Re: SONGS 2 & 3 Steam Generator Replacement Application; SDG&E Errata

Application No. 04-02-026  
Exhibit No. \_\_ (SDG&E-\_\_)  
Witness: Richard Sheaffer

**ERRATA TO**  
**PREPARED DIRECT TESTIMONY**  
**OF RICHARD SHEAFFER**  
**ON BEHALF OF SAN DIEGO GAS & ELECTRIC COMPANY**

**Figure 1-1: Incorrect Otay Mesa Interconnection Represented in SCE Filing Cases**

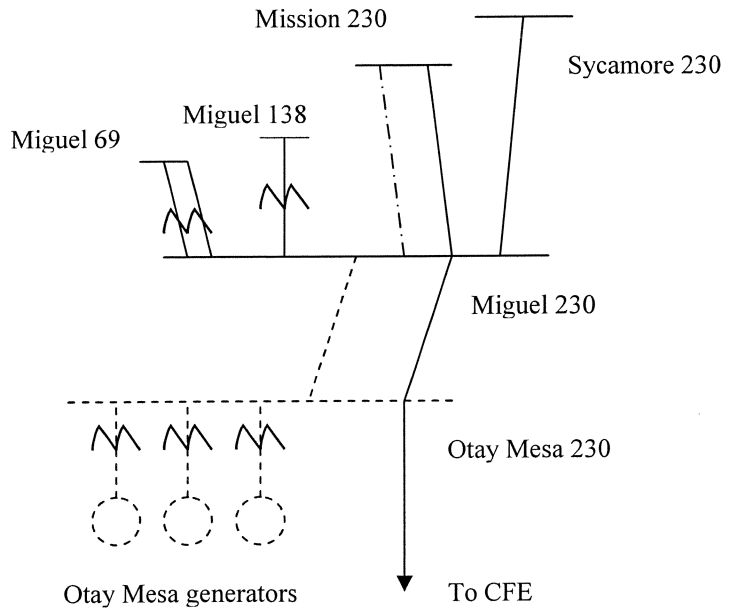
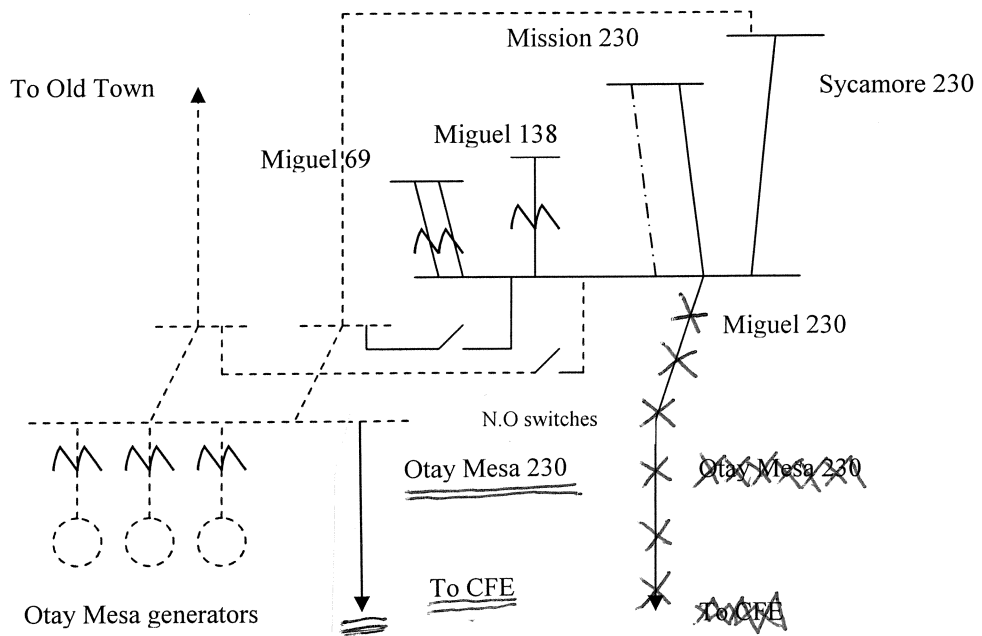
**Figure 1-2: Correct Otay Mesa Interconnection Cases**
